**SIMMONS DA-50**  
 REV F - FEB 28, 2008  
 KUSTOM AMPLIFICATION

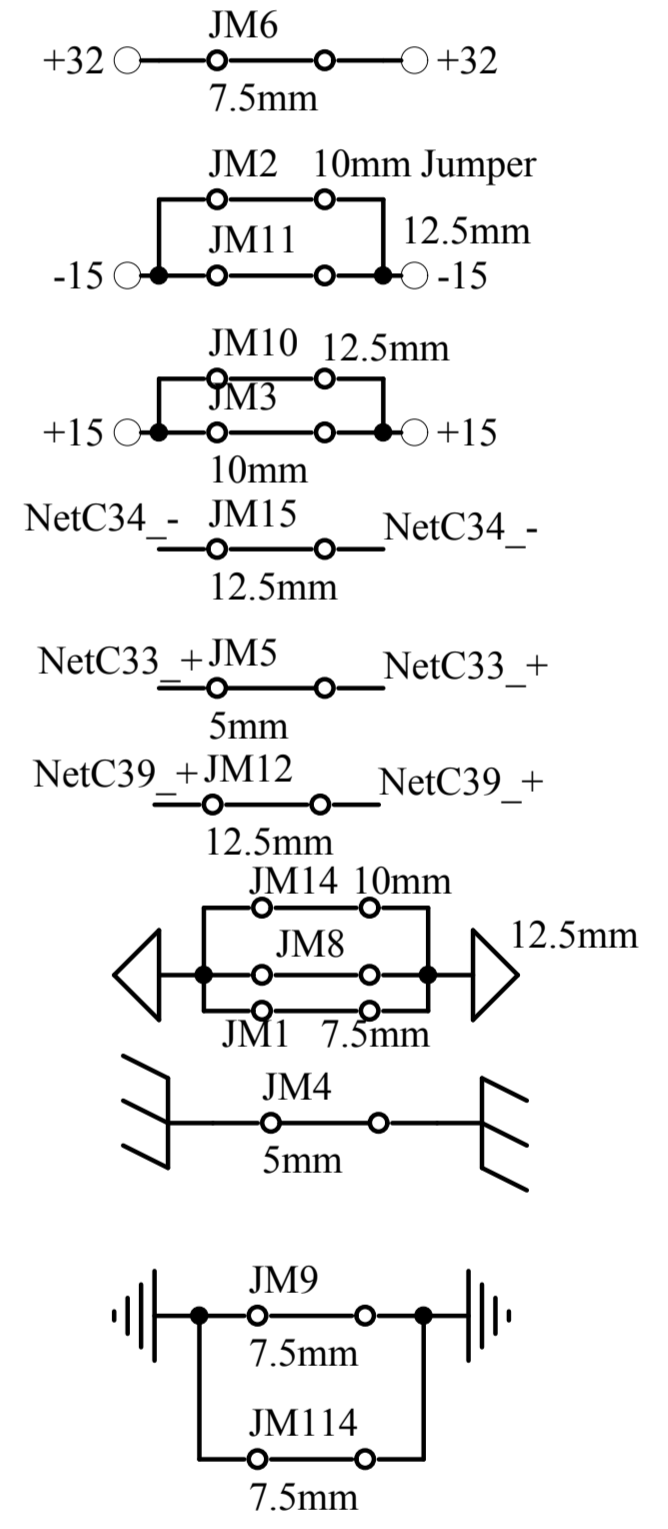
REV D to E Changes:  
 #1 R60 = 0.47, R 22 = 10 ohms  
 #2 Add 1uf 50V capacitor  
 #3 (not shown, fix hum problem)  
 Re-locate JM8 and JM14 on traces

REV F Changes:  
 1 C48 FROM .0068 TO .022 50V  
 2 SEPARATED IC4 AND IC5 ON PCB  
 3 MOVED FRONT PCB EDGE,  
 JACKS  
 AND POTS

updated linkage as far as possible

c48 from .0068 to .022

(5) pots moved up 0.5mm

(2) jacks moved down 1.25mm

added 0.5mm to pcb top

separated IC4 and IC5 more
